## MAR401/403 and MAFR401/403 Series Order Code Change Notification

MAR401/403 · MAFR401/403 series

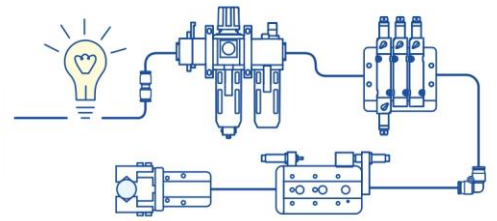
As the product adds the panel mounting function, the order code changes the brackets to optional. Customers can choose according to needs.
